Preliminary Consultation
MONTGOMERY COUNTY HISTORIC PRESERVATION COMMISSION
STAFF REPORT

Address:	7209 MacArthur Blvd., Bethesda	Meeting Date:	10/26/2022
Resource:	Contributing Potomac Overlook Historic District	Report Date:	10/19/2022
Applicant:	Kim & Arthur Newmyer (Robert Black, Architect)	Public Notice:	10/12/2022
Review:	HAWP	Staff:	Dan Bruechert
Proposal:	Partial demolition and construction of a new rear addition, hardscape alteration, and fenestration alterations.

LOWER LEVEL PLAN

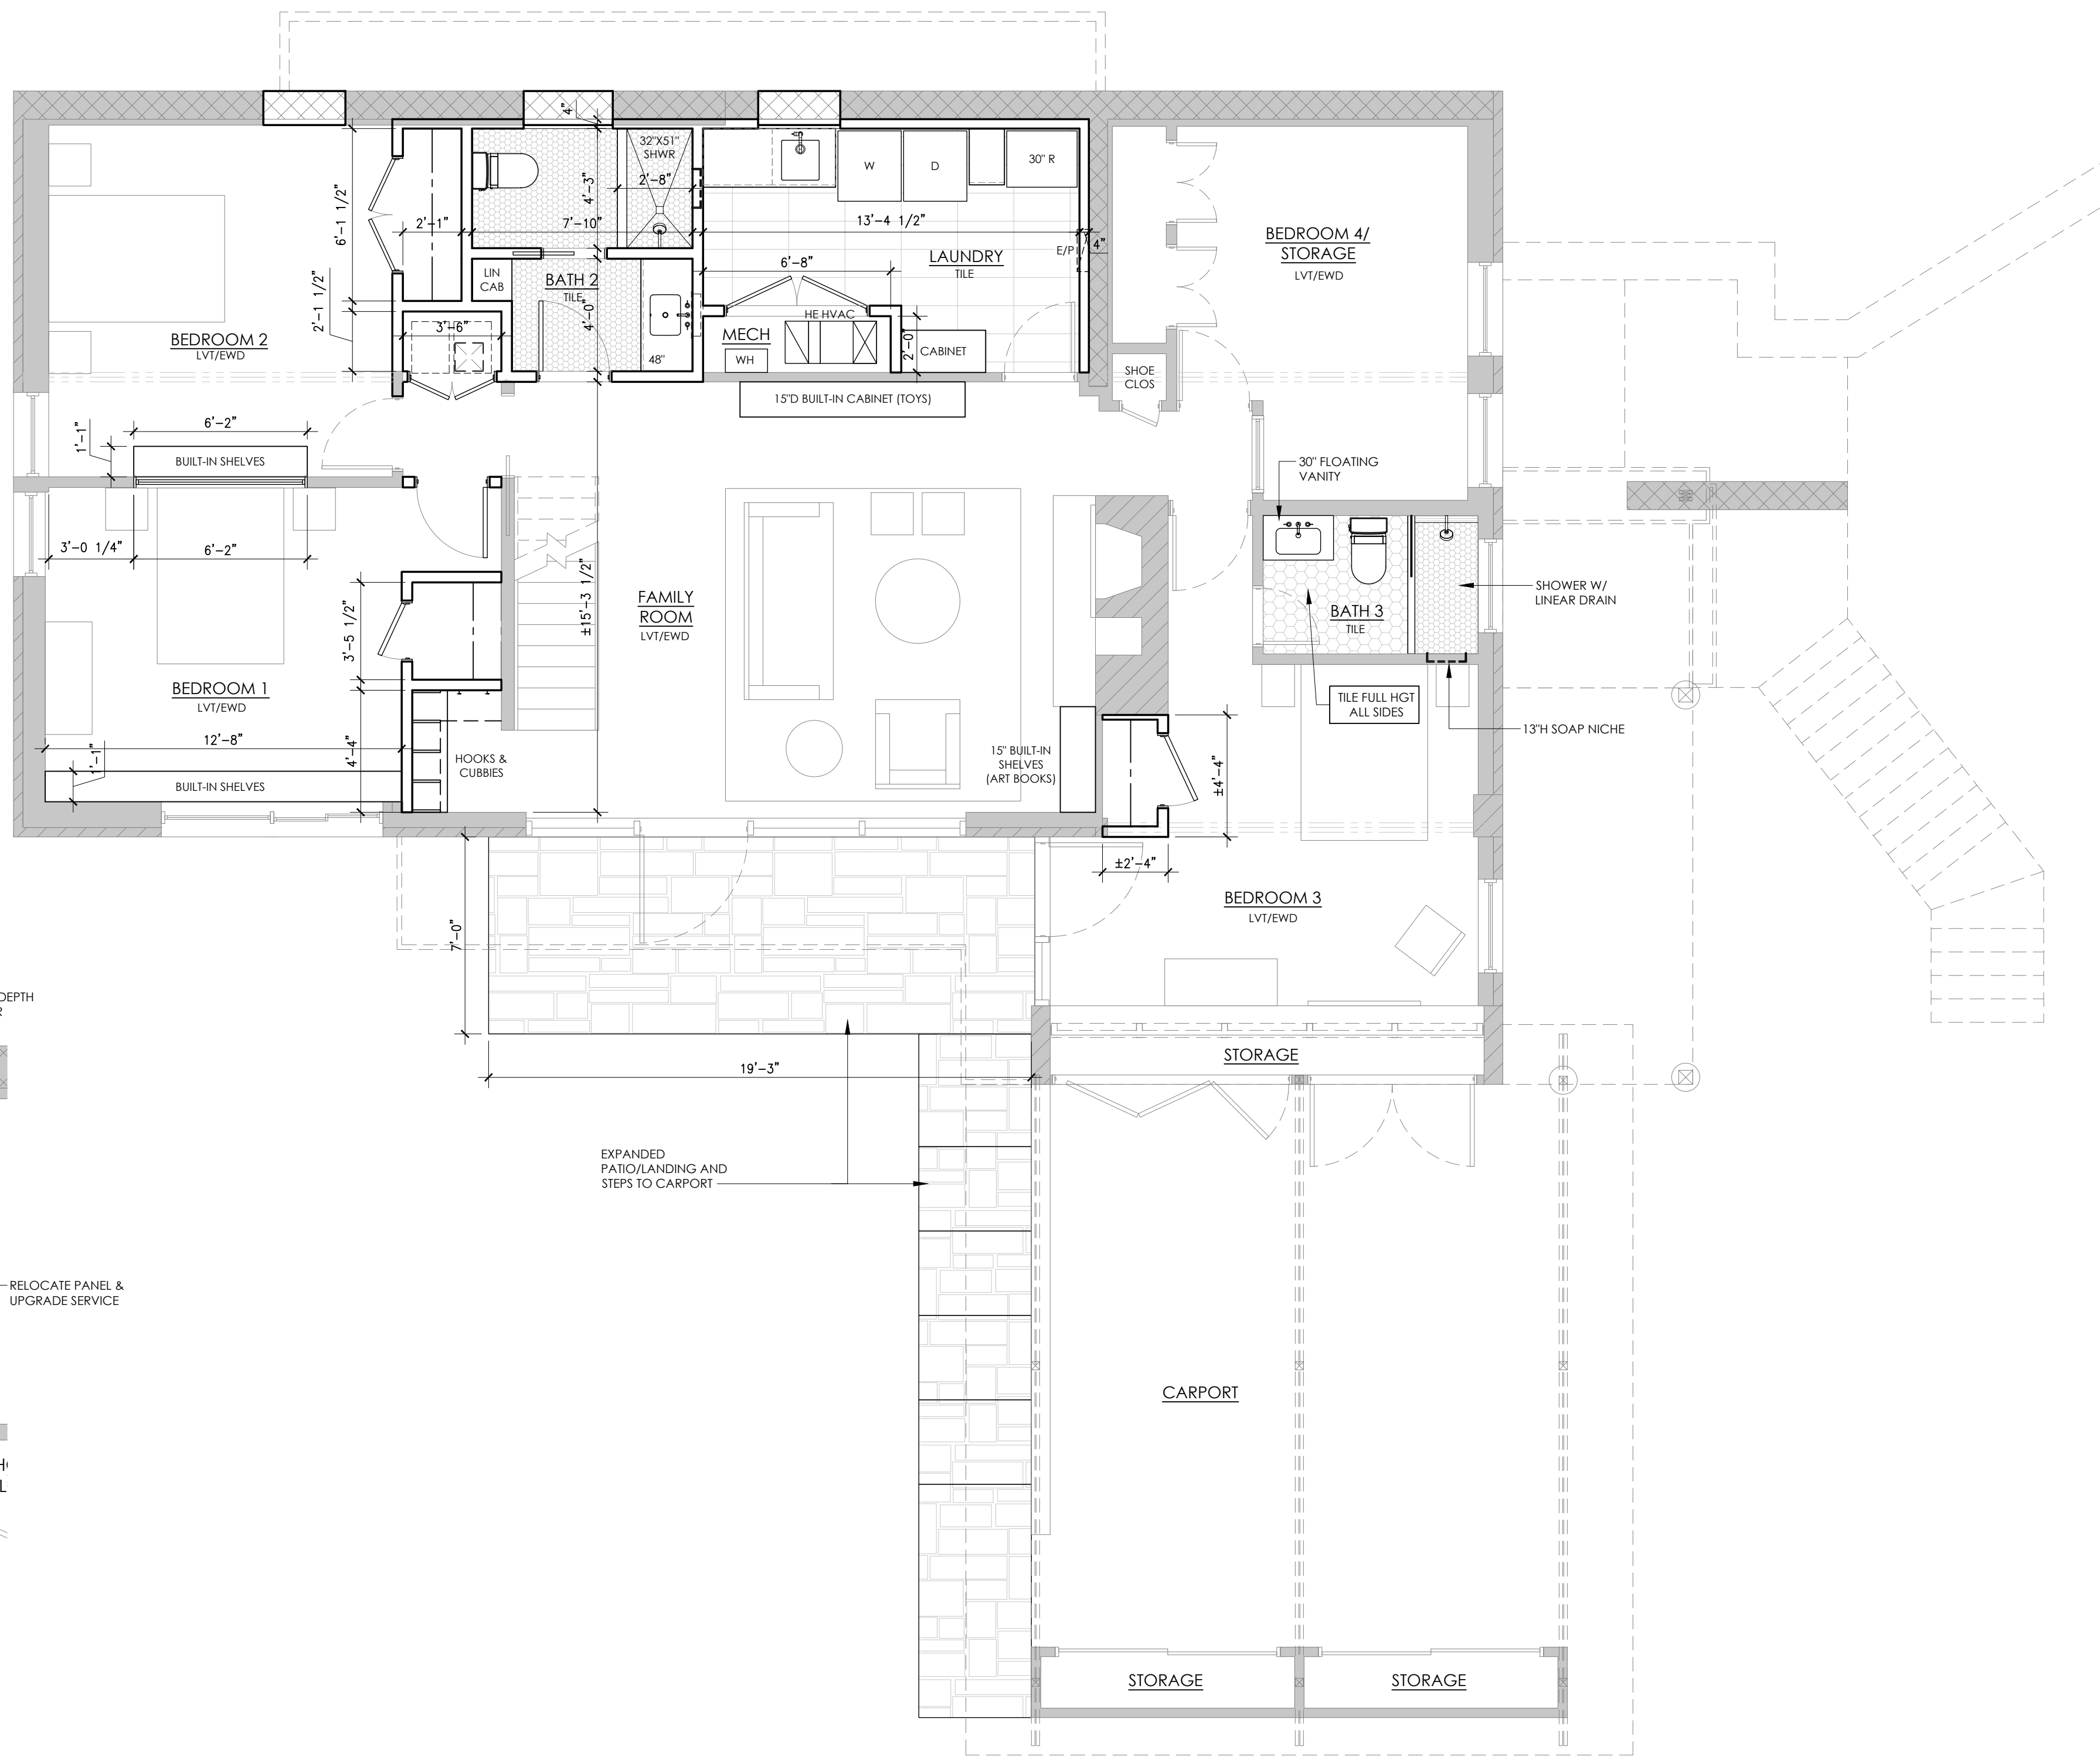
The plans show an expanded patio/landing and steps to the carport on the proposed floor plans. No details about this element's current condition or materials proposed were included with the application; and without that information, Staff cannot provide any feedback about that proposal. More details are needed with the HAWP application for a thorough evaluation.

On the rear of the subject property, a previous owner constructed a small, largely glazed, rectangular bay bump-out with sliding glass doors. The applicant proposes to demolish this feature and construct a new rear addition that measures 2' 10" (two feet, ten inches) from the historic wall plane and is 31' 7" (thirty-one feet, seven inches) wide. The addition will be installed under the existing roof eave. The addition's proposed siding is fiber cement tongue and groove siding selected to replicate the appearance of T1-11 siding. At the rear of the addition, the applicant proposes to install a large sliding glass door and two casement windows (a single lite casement and a unit that appears to have a large fixed lite and a smaller operable unit). There is a discrepancy between the floor plans and the elevation drawings for the larger casement window. The floor plans show a single-lite window, but the elevation drawing shows a two-lite window. The applicant should clarify this element at the Preliminary Consultation hearing, and drawings submitted for the final HAWP need to be consistent.

Staff finds the existing bay is not historic and may be removed. The *Guidelines* encourage placing additions at the gable end of the house, to the greatest extent possible, to allow the buildings to "retain their character defining form." Staff finds, however, that the placement of this small addition (less than 90 ft²) will not be largely visible from the most architecturally significant elevation. Additionally, because the proposed addition will be entirely under the roof eave, Staff finds the impact on the overall house massing will be minimal. There will however be a change in the relationship between the deep roof overhang at the eave and this new addition. The half-round gutters will project beyond the addition's wall plane. Additionally, the fenestration on this elevation will be changed on the addition. The *Guidelines* state the fenestration should be preserved and maintained, however, the rear wall on this elevation will be removed. As this is the first proposal in the newly designated Potomac Overlook Historic District, Staff requests significant feedback from the HPC regarding the appropriateness of the proposed addition and the changes to the fenestration.

The size and placement of the existing bay will require removing three ground-floor windows. The windows are below grade and receive light through existing window wells. Because of their limited visibility, Staff would support removing these windows as part of a HAWP application.

PROPOSED MAIN LEVEL PLAN

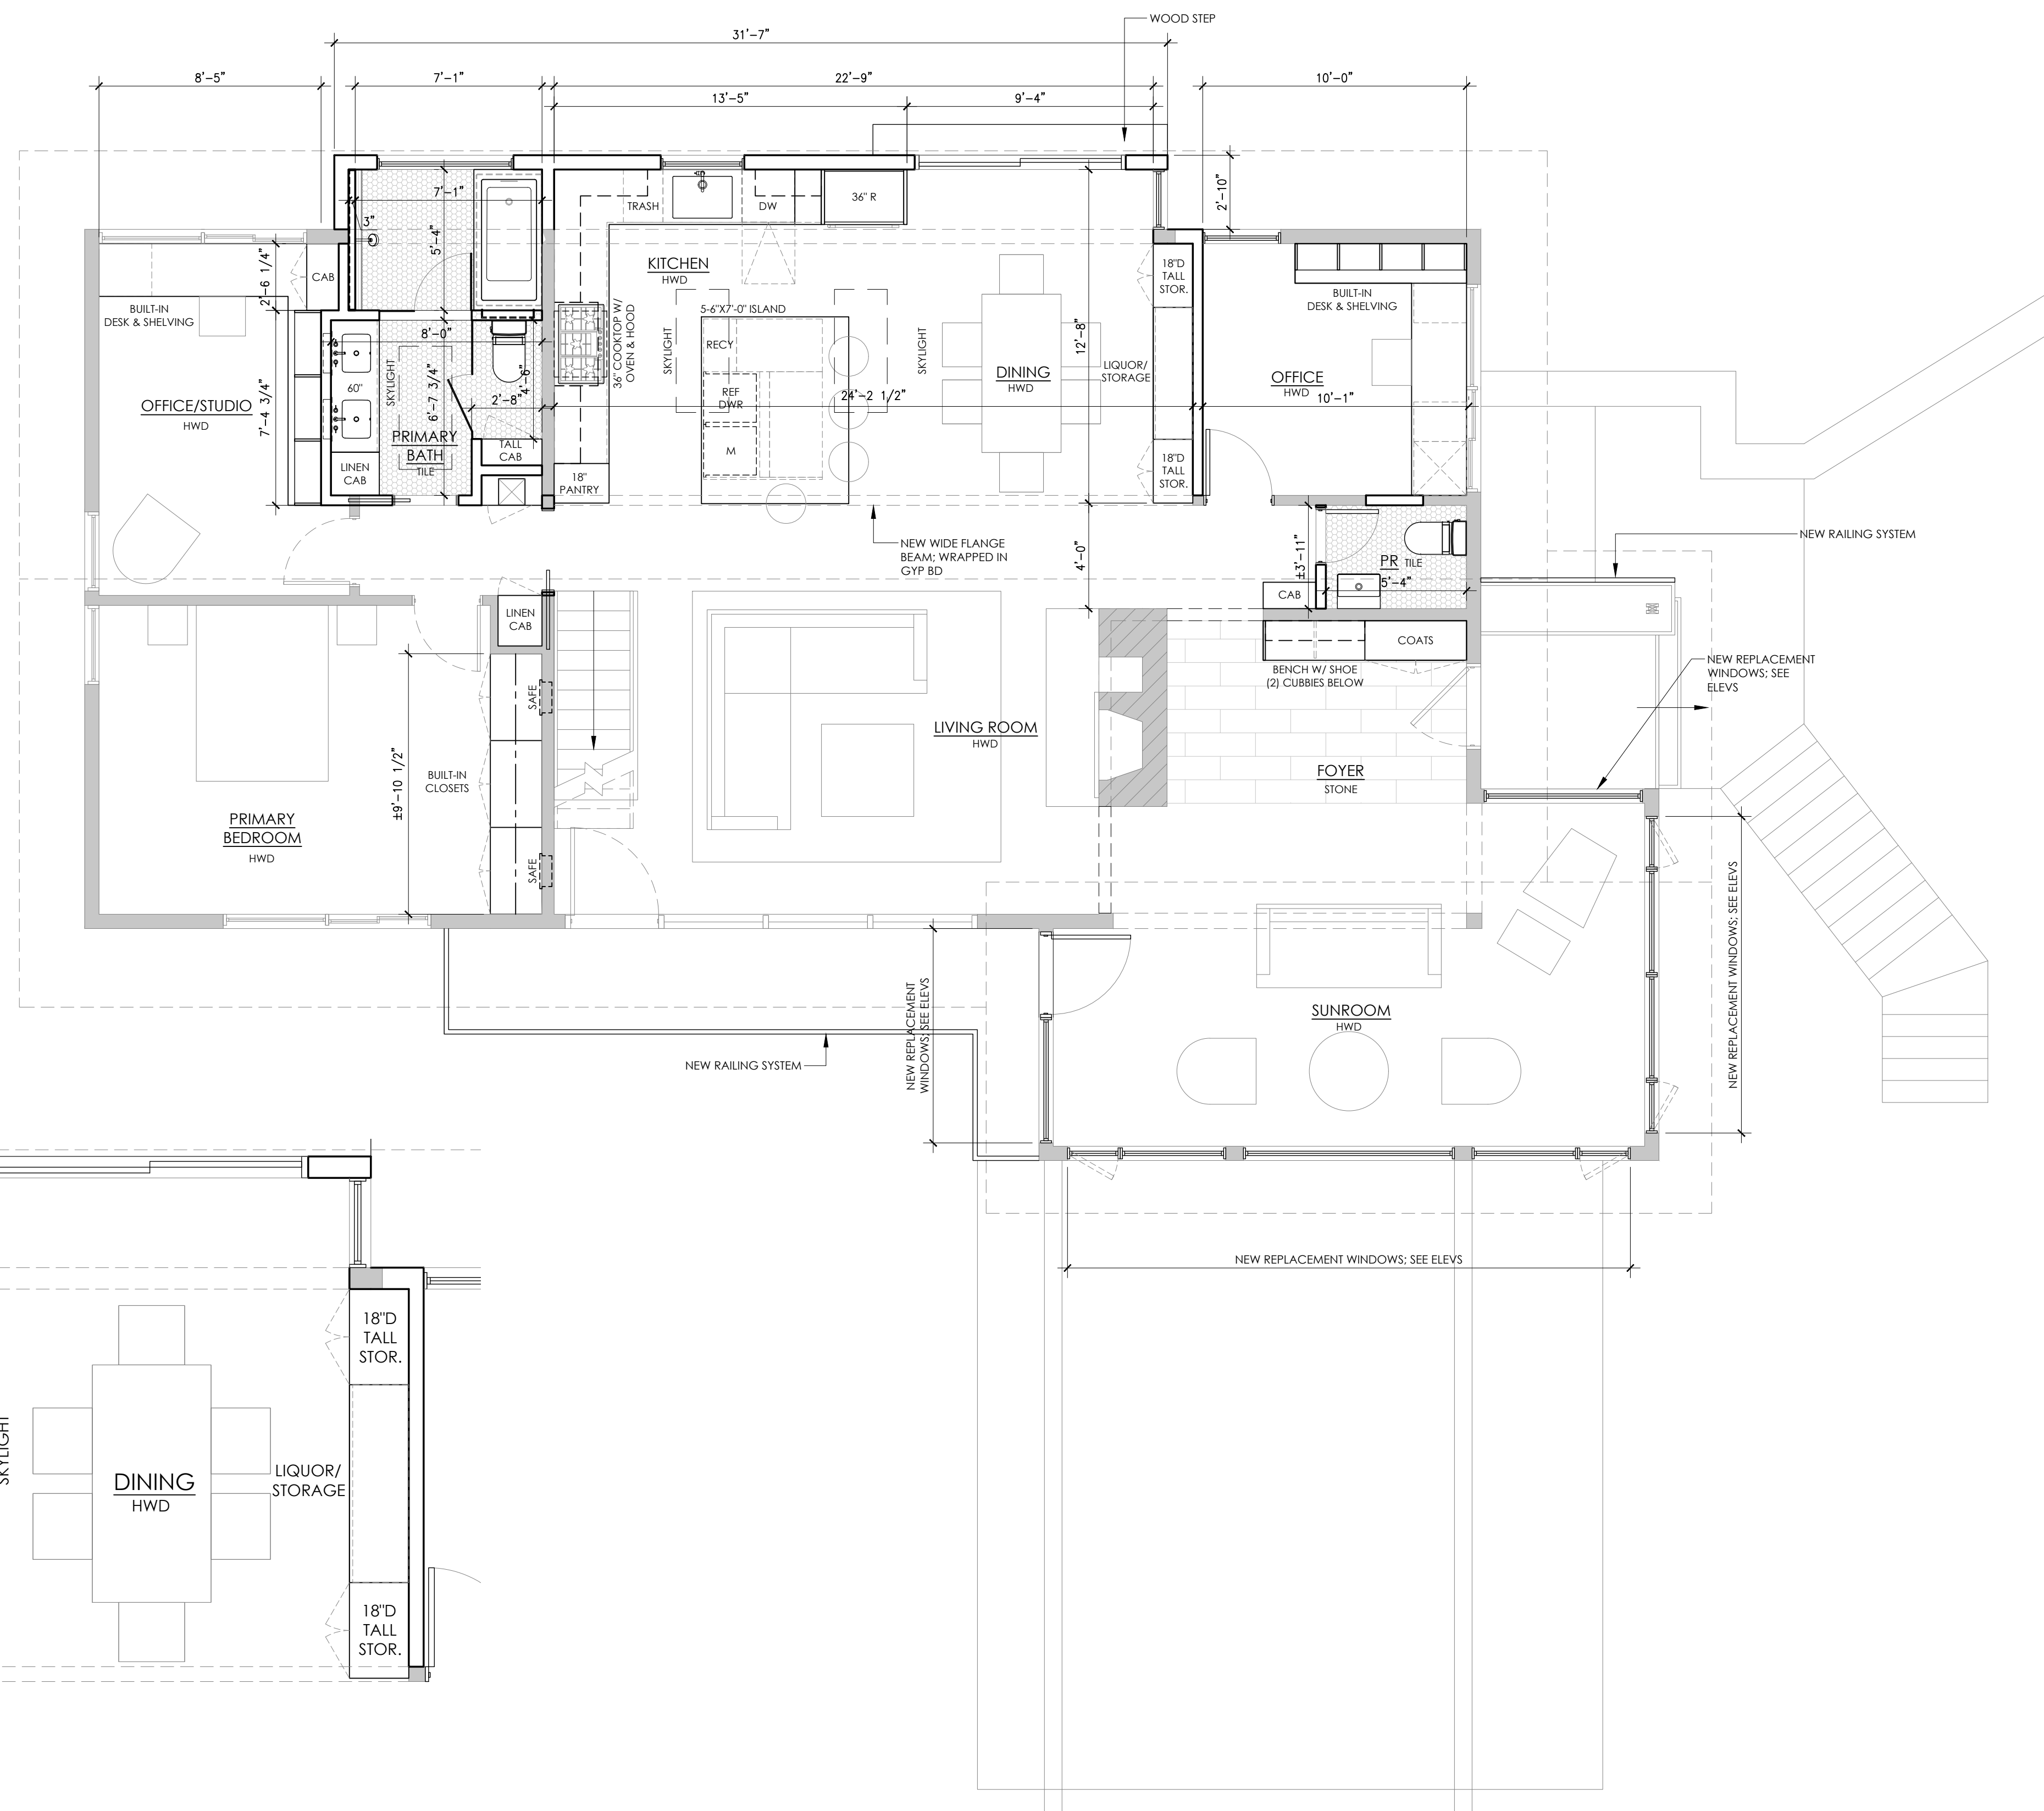
The application states that the proposal will replace the existing bubble skylight and install a new skylight. The proposed main floor plan shows two skylights in the kitchen and one in the new bathroom. These skylights are all on the rear roof slope and Staff does not find they will detract from the character of the house. In looking at photos of the subject property, it appears that there is only one skylight currently on the roof’s rear slope.
